**Subject: ITB #26071-B Justice Center Roof Replacement
Addendum #2**

FAYETTE COUNTY
JAIL EXPANSION
& CRIMINAL
JUSTICE CENTER

TITLE
**ROOF PLAN
& DETAILS**

A1.03

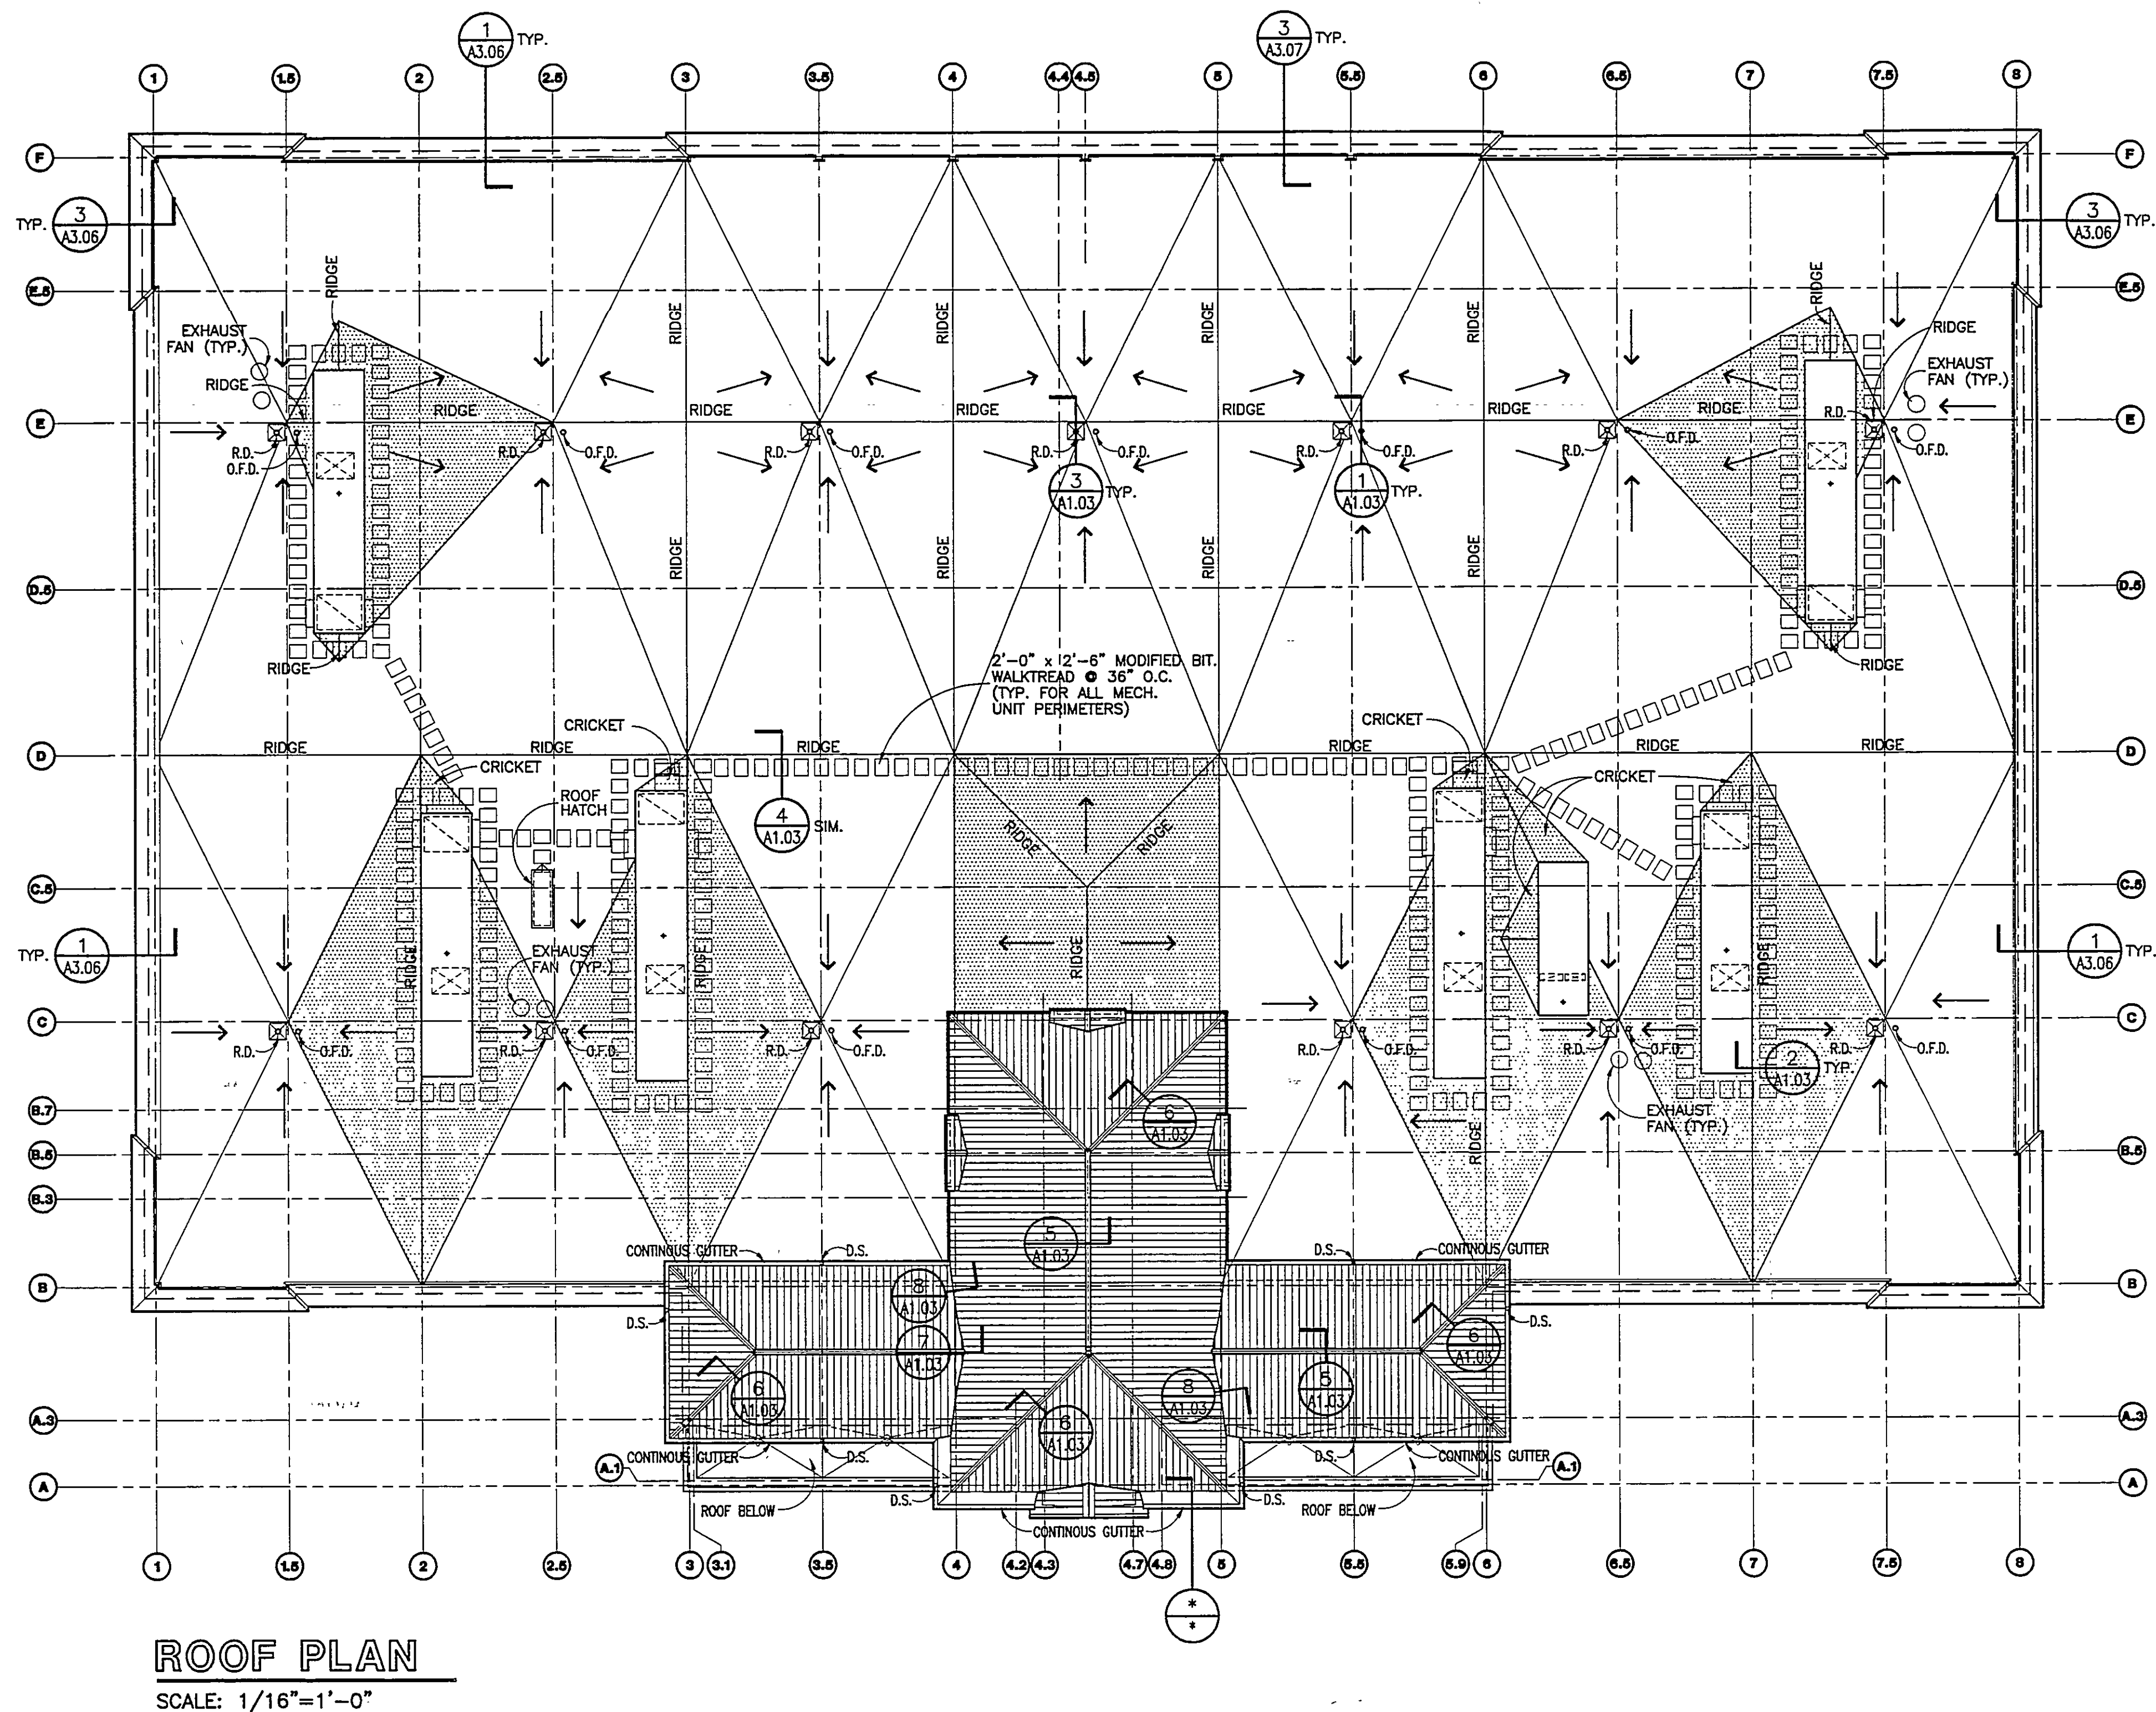
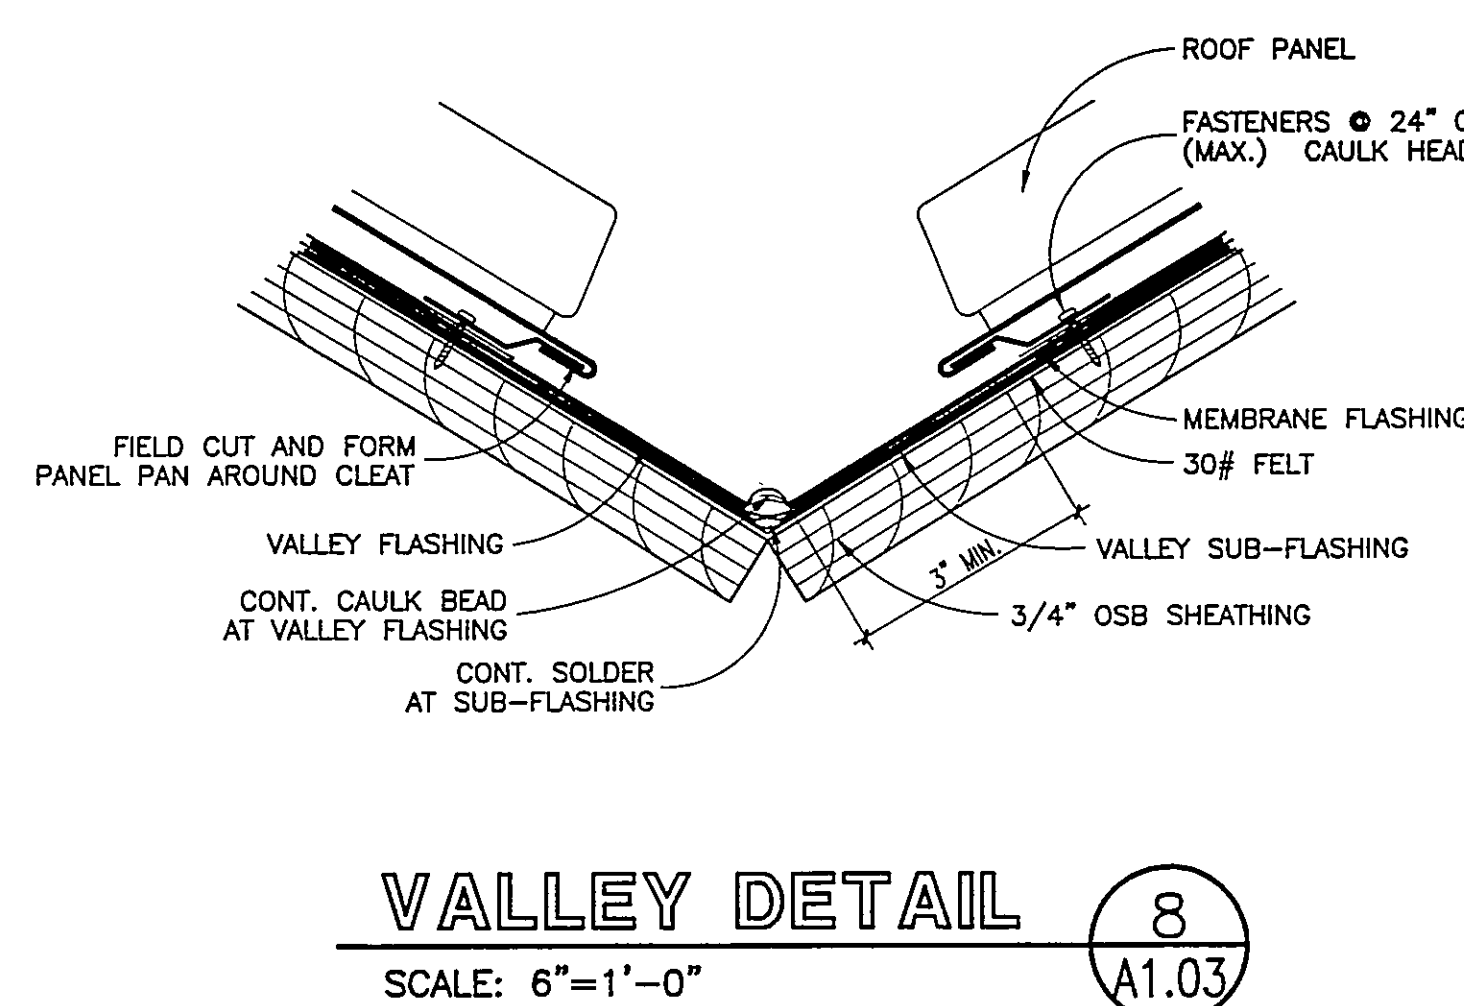
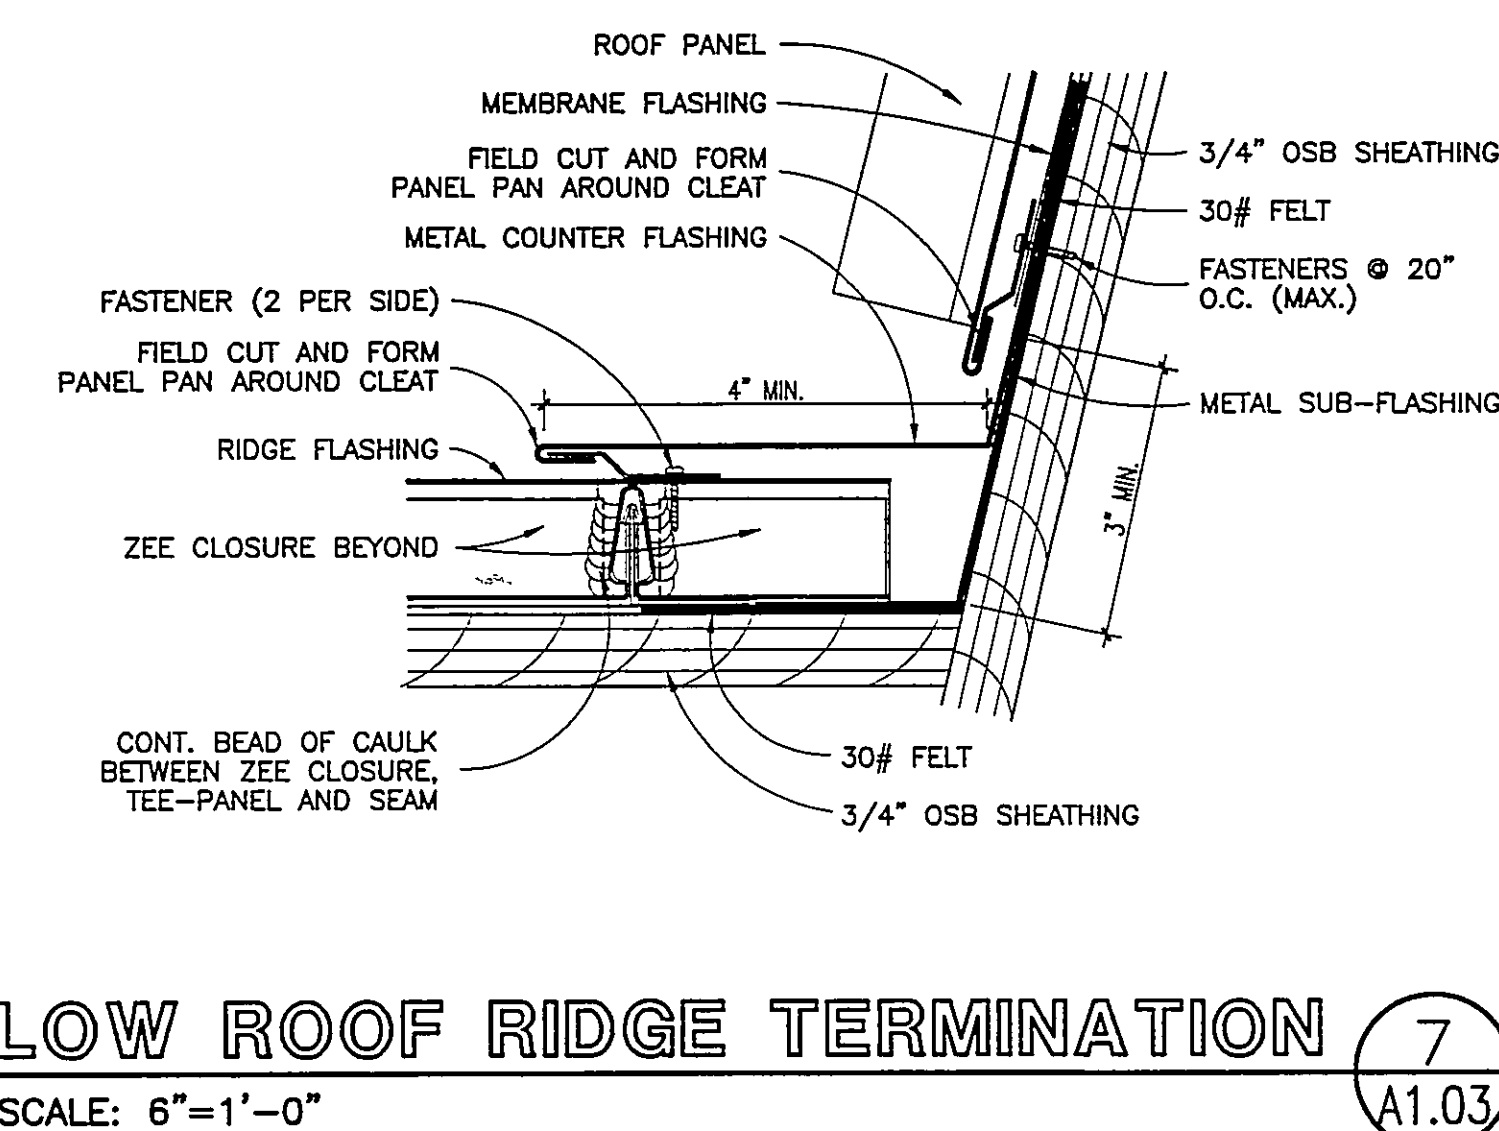
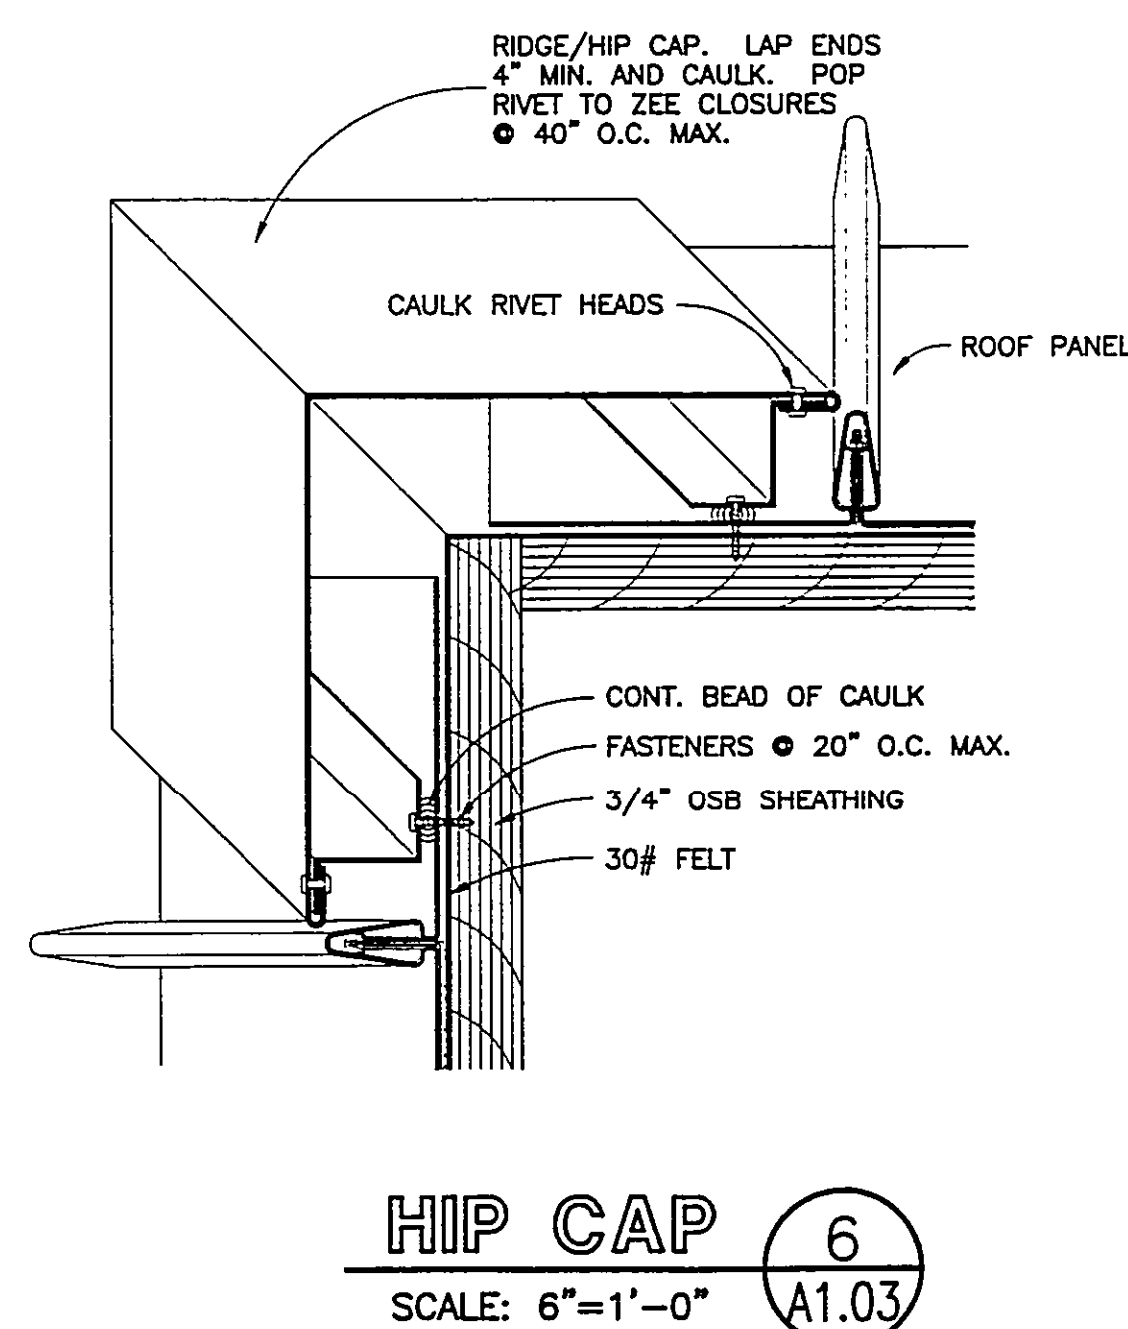
4. Are there any plans for the existing roof? **See Attachment 1.**
5. Will the contractor be responsible for the lightning rod removal and recertification after replacement? **Yes. Each bidder should include (In base Bid) the costs for a certified Lightning Protection installer to have the existing system removed and replaced upon roof completion and a certified Letter of findings upon completion.**
